Access Compliance Report

Public Rights-of-Way

(Pedestrian Signals)

Intersection ID: N/A	Main Street:	Cross Street: N/A	Location: N/A
ADA ID: BC497467CE64	Signal Type: Two Push Buttons-Non APS	Overall Compliance: No	Severity Score: BTN 1:N/A BTN 2: N/A No BTN: N/A
Codes/Mitigation Info/Possible Solution		Field Measurements/Component Compliance

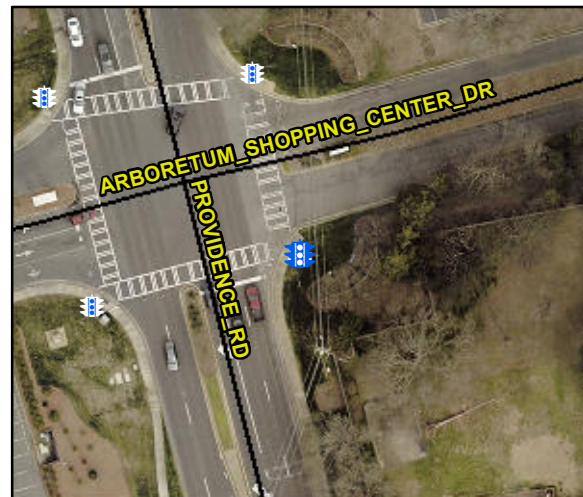
PROW/ADA: R404.2, R404.3

Possible Solutions: Remove and Replace Clear Space.
